**Re: Contract No. HY/2009/15  
Central – Wan Chai Bypass – Tunnel (Causeway Bay Typhoon Shelter  
Section)  
Landscape Plan (Rev. 7)**

**Landscape Plan (Revision 7) under FEP-06/364/2009/A for Contract No. HY/2009/15**

# **Landscape Plan**

<b><u>PlanD's observation / comment via email dated 21 April 2021</u></b>	<b><u>Responses</u></b>
Central-Wan Chai Bypass –Tunnel (Causeway Bay Typhoon Shelter Section) <u>EP Condition 2.10: Landscape Plan (Rev.6)</u>	
i) You are required to include a set of latest record of all preserved tree within the project boundary of this FEP	Added in Appendix M

TITLE:  
TREE PRESERVATION PLAN OF REMAINING AREA PART OF PORTION VII POSSESSED BY HY/2010/08 CONTRACTOR

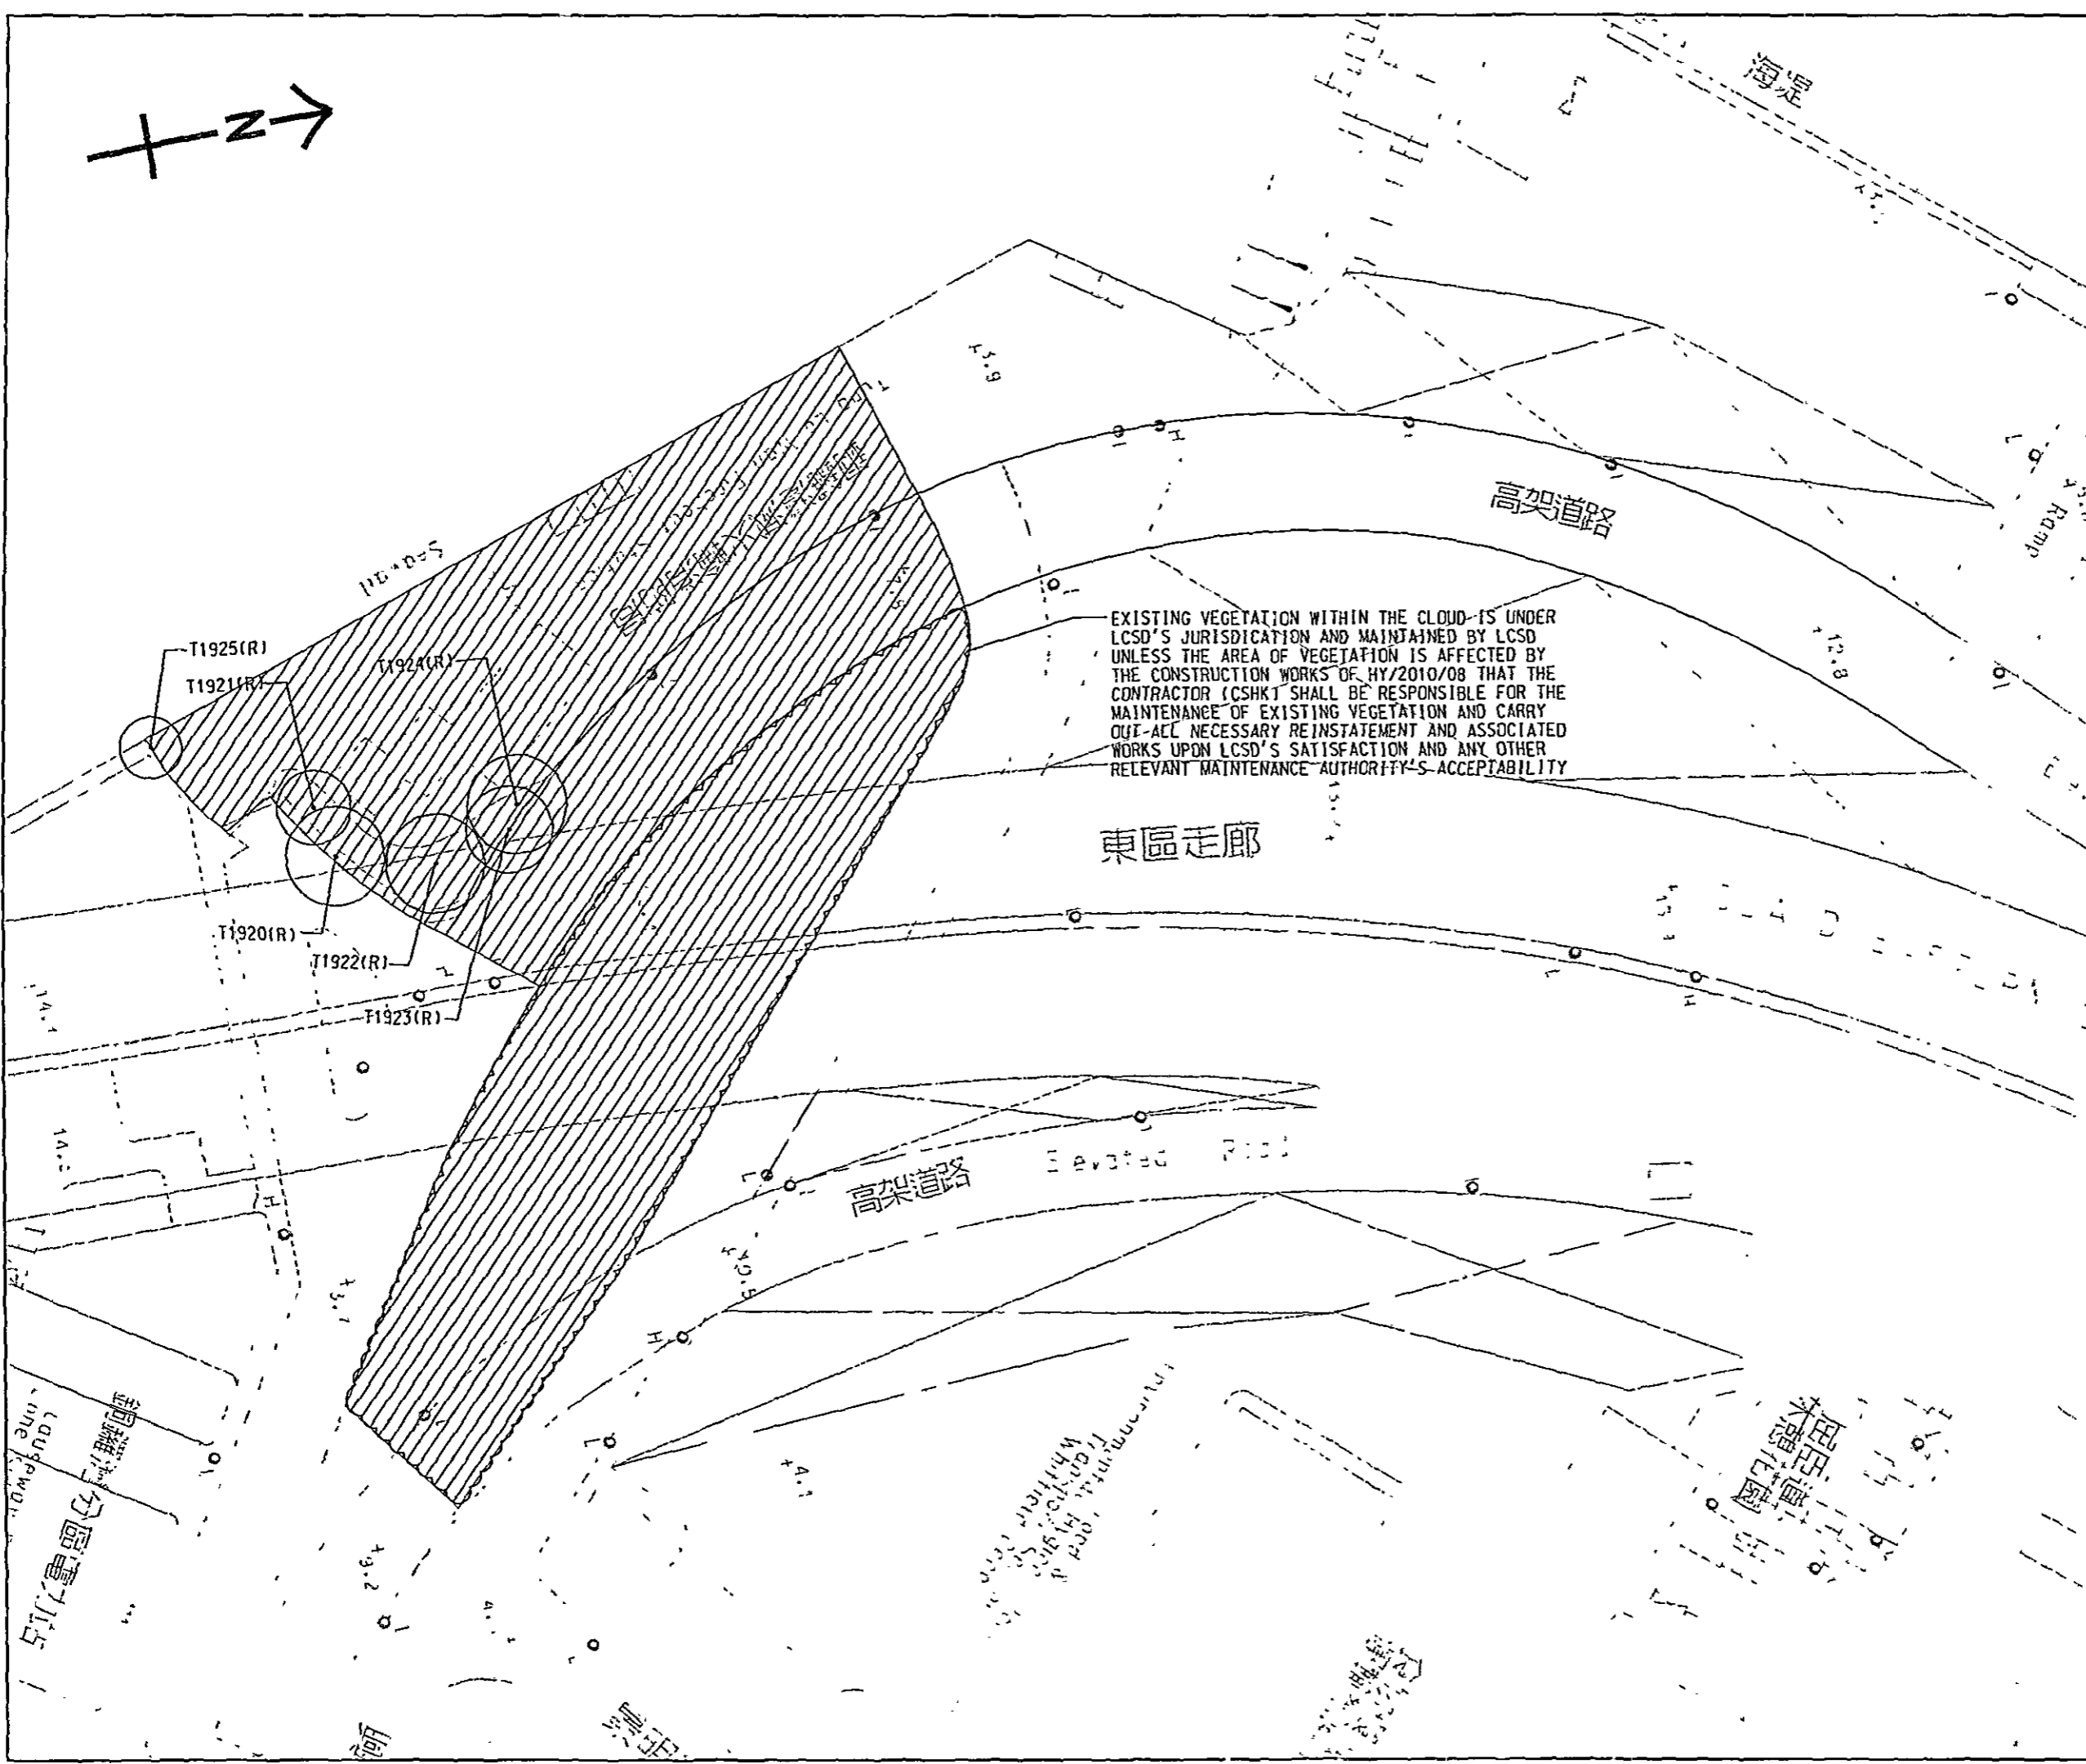
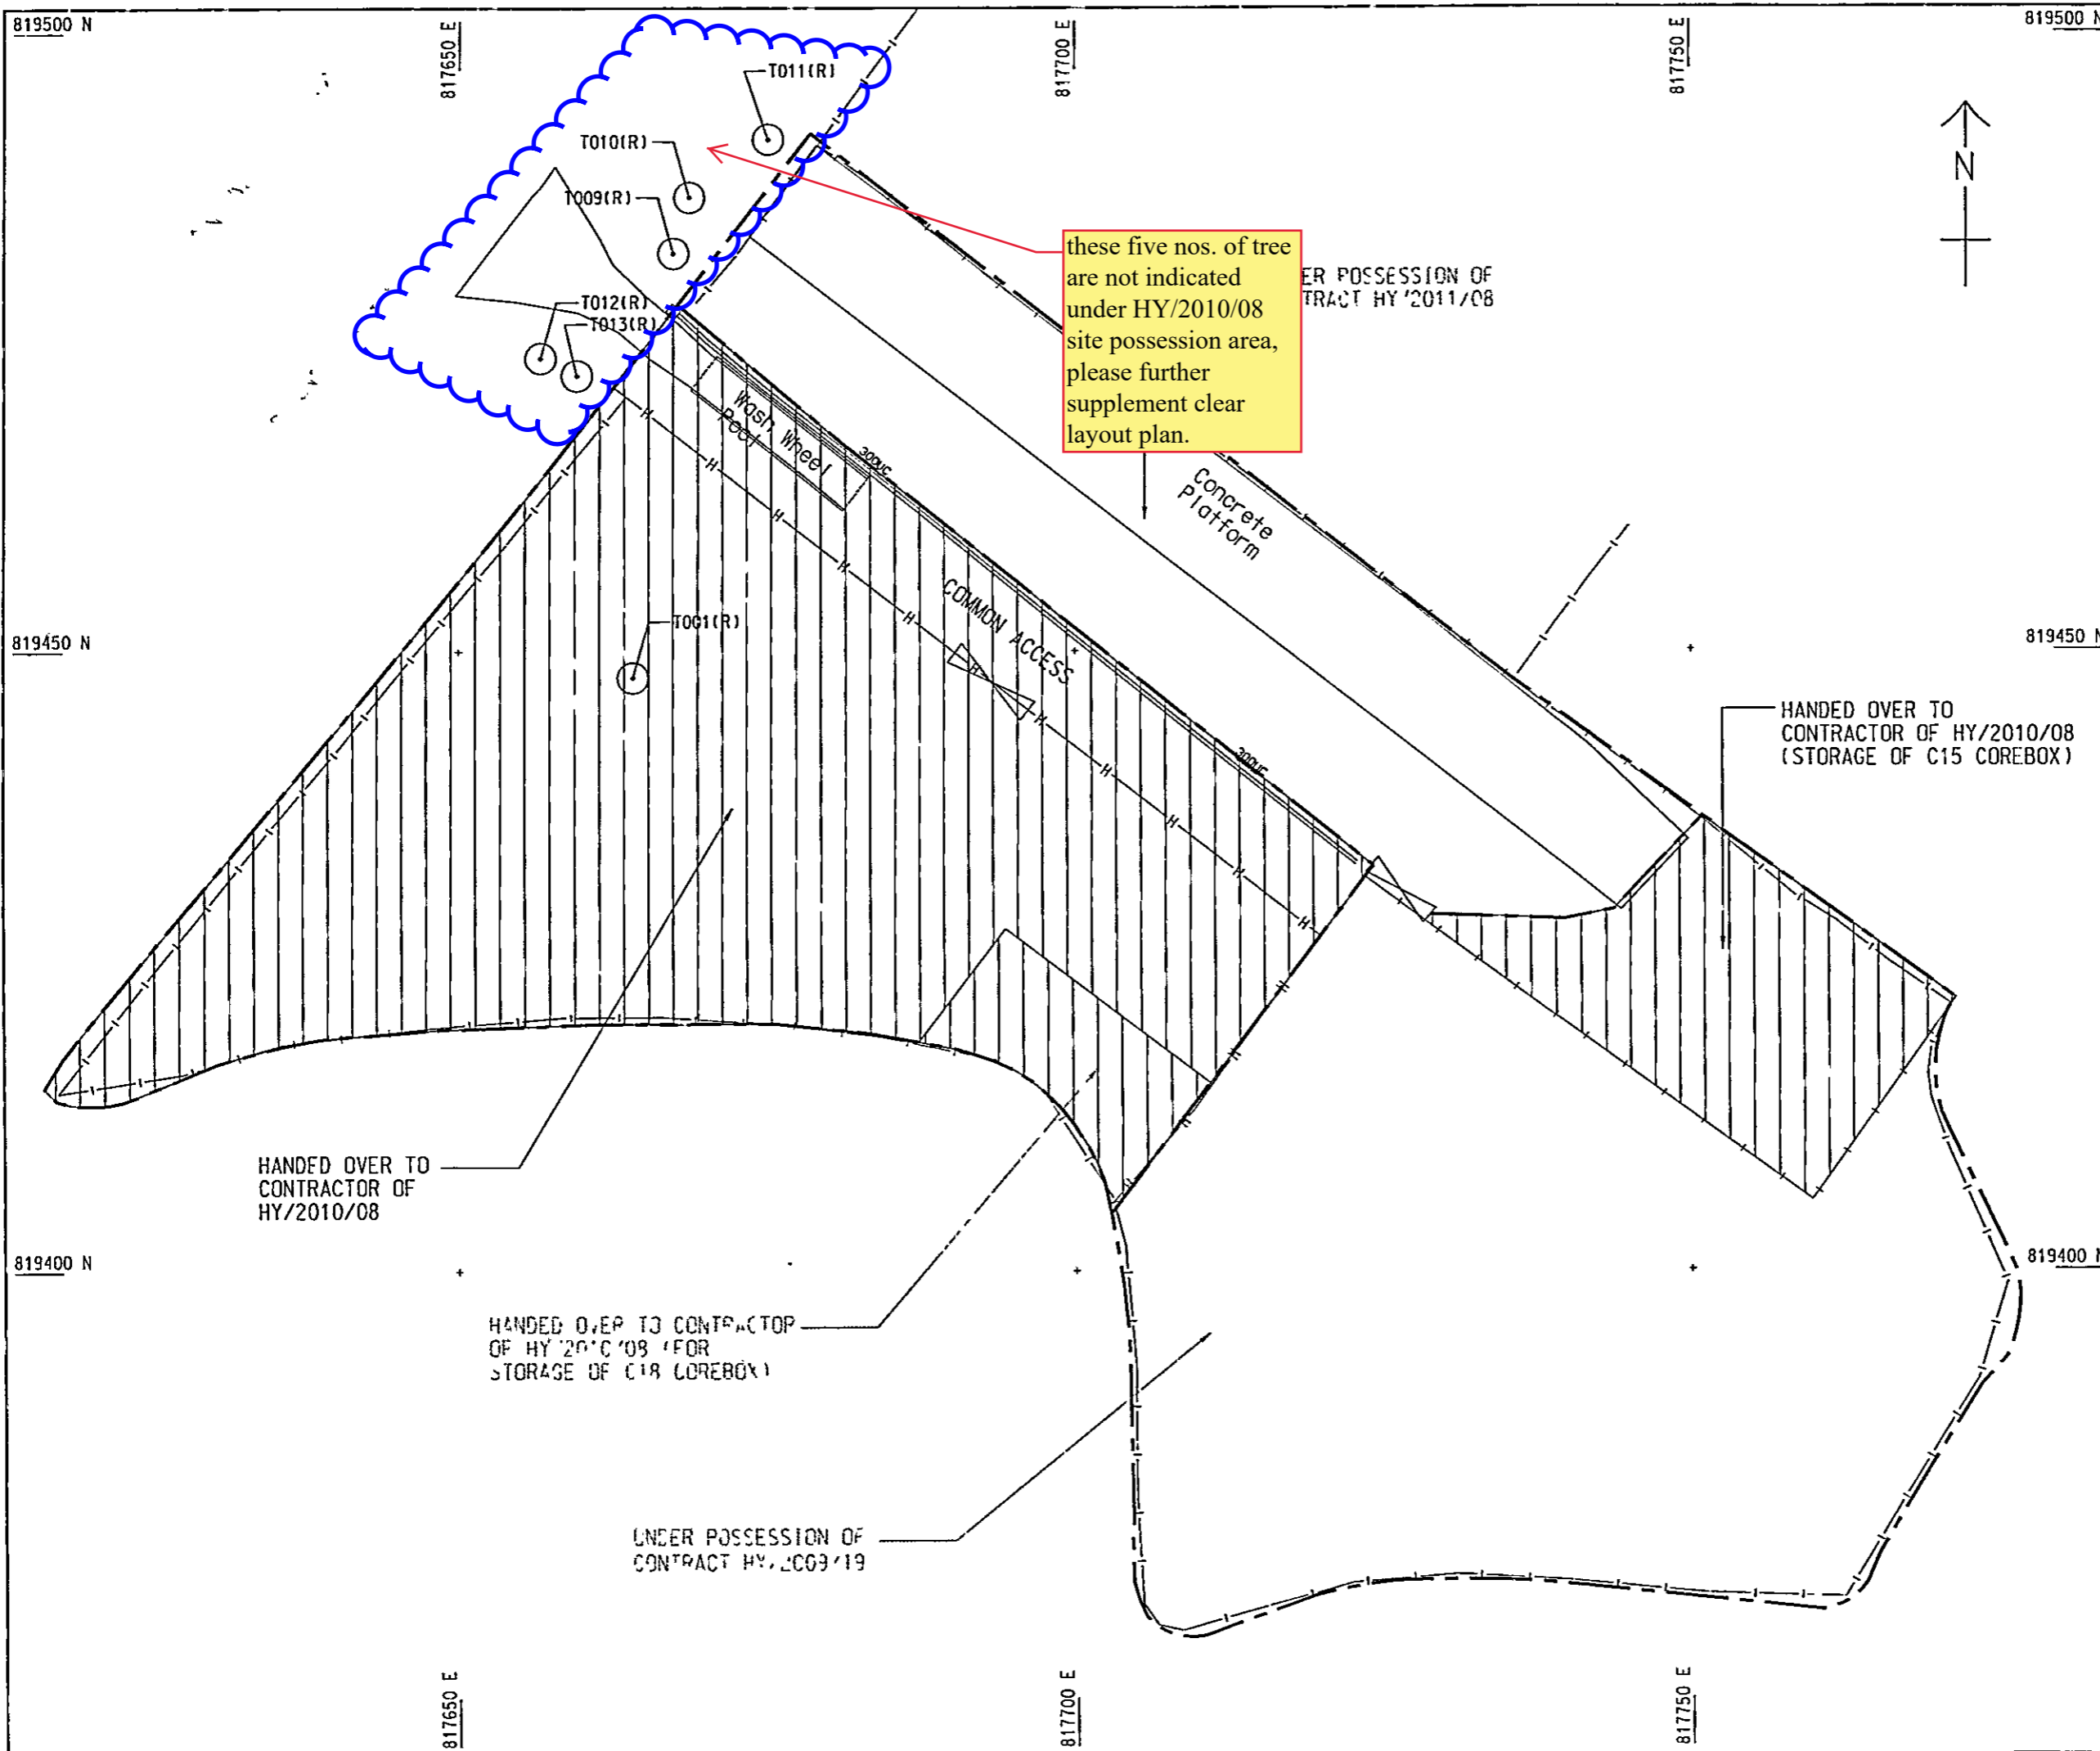
these five nos. of tree are not indicated under HY/2010/08 site possession area, please further supplement clear layout plan.
